SERVICE BULLETIN

SB No. 79 Issue No. 1

TITLE INSPECTION OF CONTROL COLUMN TO SEAT CLEARANCE AND SEAT ATTACHMENT INTEGRITY

APPLICABILITY: T67C & T67M-MkII Aircraft (Post Mod M445),
 T67M260 & T67M260-T3A

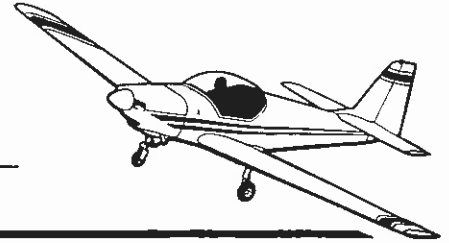
It has been reported that in some cases, due to oversize holes having been drilled in the seat/seat access panel attachment screw holes, the control column can foul front of seat.

FIG. 1

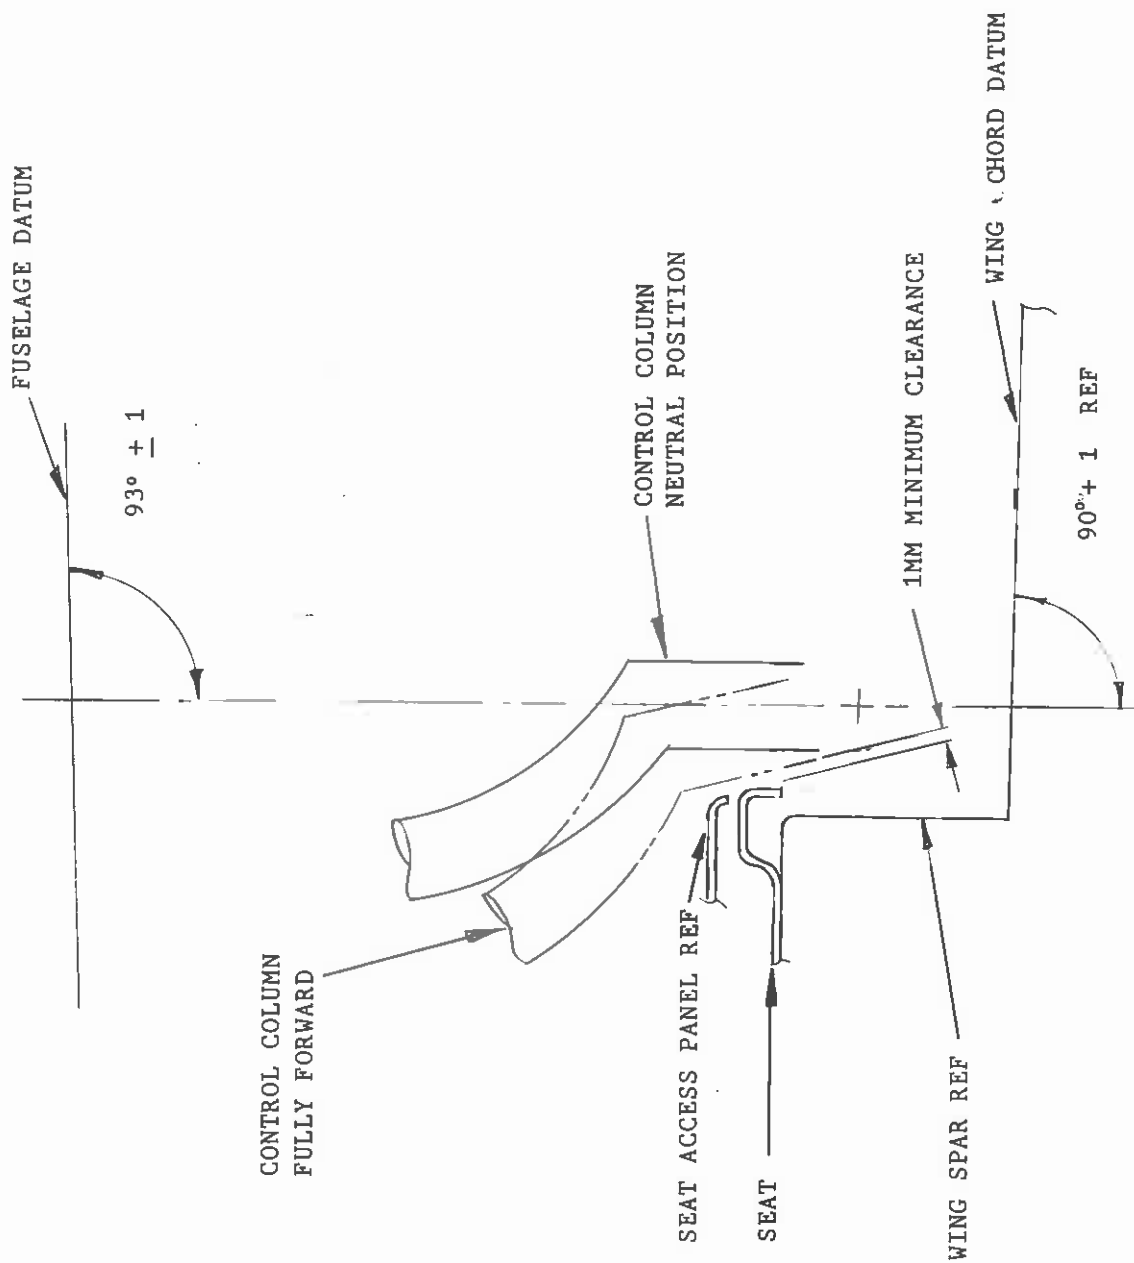
- a) Inspection Before Next Flight:
1. Remove control column gaiters and check for a minimum clearance of 1mm between control column at its fully forward position and the seat/seat access panel structure, Ref. Fig. 1.
 2. If clearance is 1mm and more annotate Aircraft Log Book SB 79 accomplished.
 3. If clearance is less than 1mm, check control column rigging, Ref. Fig. 1, and elevator movements are within tolerances. Refer to relevant aircraft Maintenance Manual. Remove centre console to achieve control column rigging.
 4. If action 3. achieves the required clearance, annotate Aircraft Logbook SB79 accomplished.
 5. If action 3. does not achieve required clearance, then Mod M665 Introduction of Locating Spigot is to be invoked.
